**ADDENDUM NO. 1**

PROJECT TITLE:  
**BRIDGE NO. 03160A-D, 3301 & 3303 I-84 EB/WB OVER AMTRAK & LOCAL ROADS (AETNA VIADUCT)**

TOWN: **HARTFORD**  
DRAWING TITLE:  
**SUBSTRUCTURE REPAIR - BRIDGE 3160B PIER NO. ES3**

**MEDIAN DEMOLITION LIMITS**

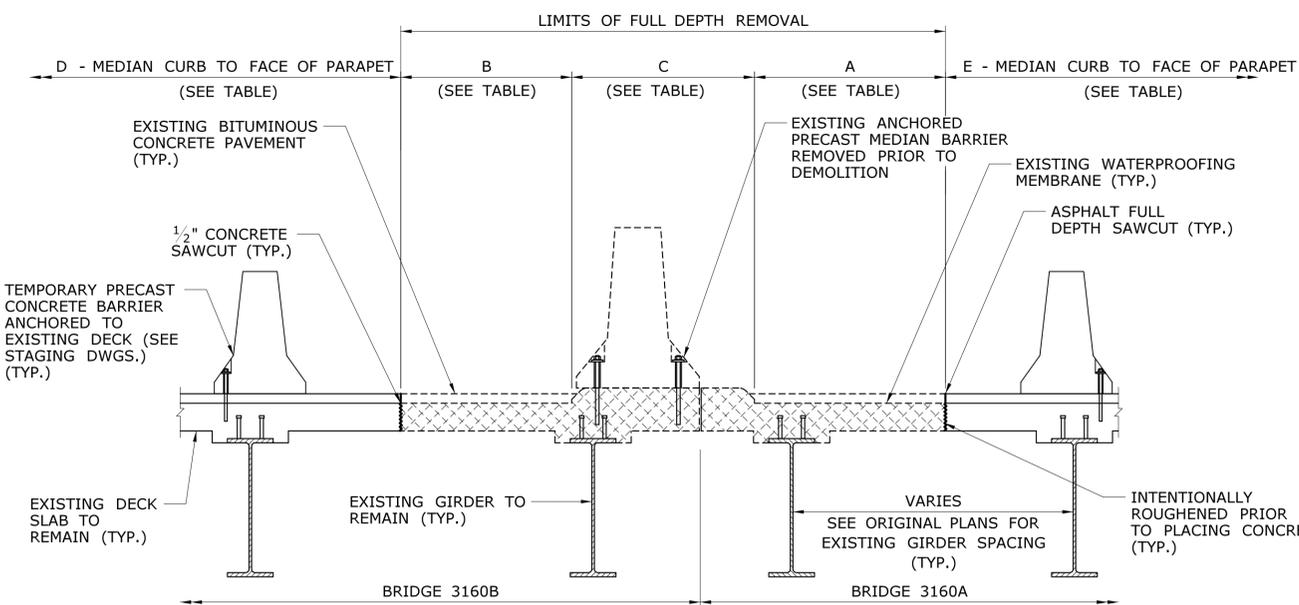
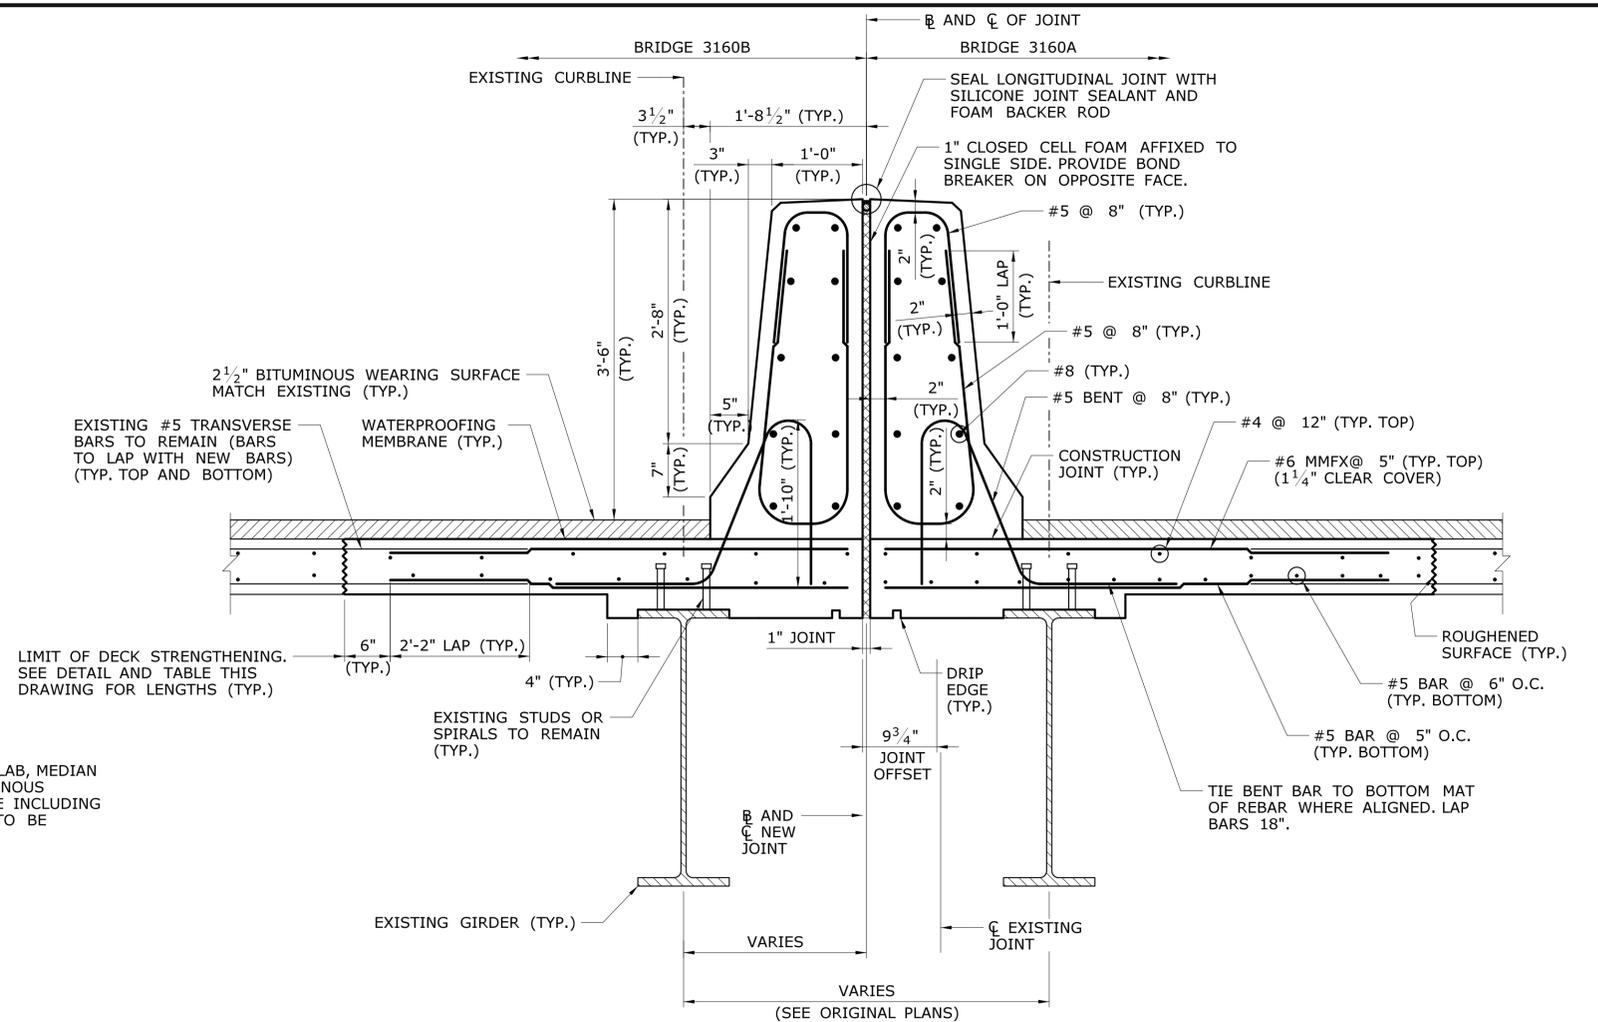
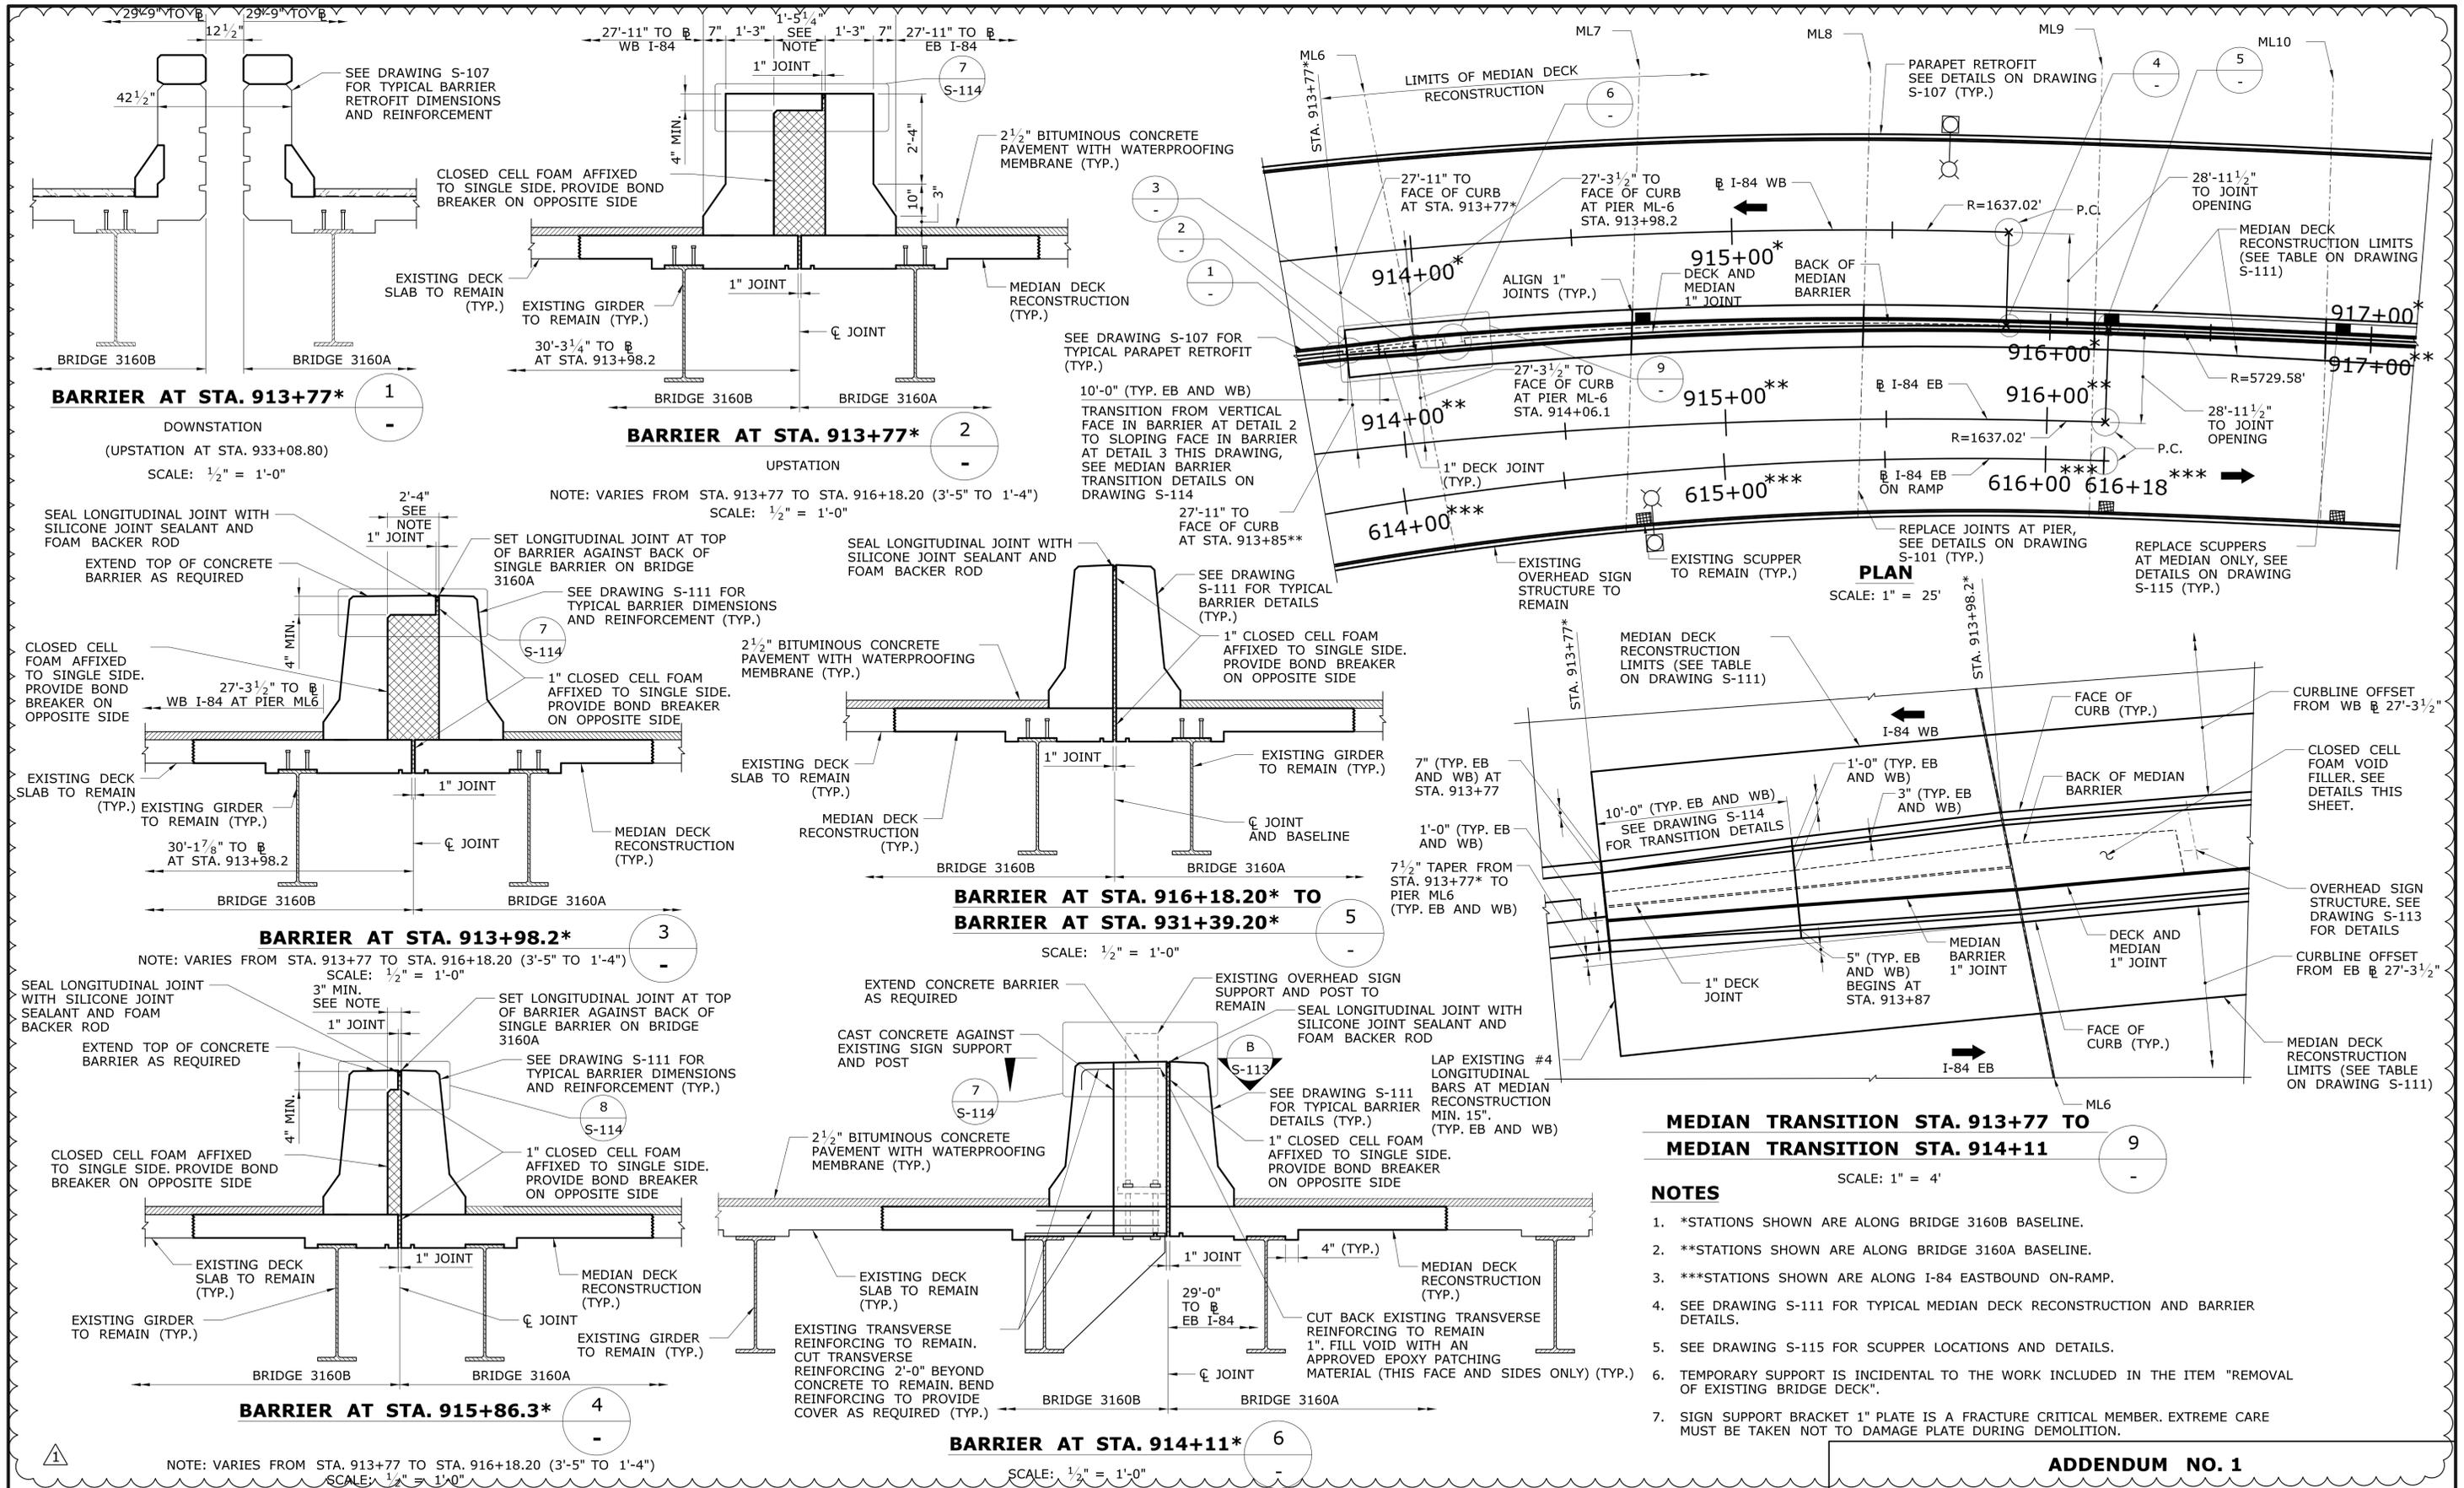
REV.	DATE	REVISION DESCRIPTION	SHEET NO.
1	9/29/16	REVISED MEDIAN REMOVAL LIMITS	01.08.115

- DEMOLITION OF EXISTING CONCRETE DECK AND MEDIAN CURBS SHALL BE PAID FOR UNDER THE ITEM "REMOVAL OF EXISTING BRIDGE DECK". THE COST TO REMOVE THE EXISTING PRECAST MEDIAN BARRIER IS INCIDENTAL TO THE DECK DEMOLITION ITEM.
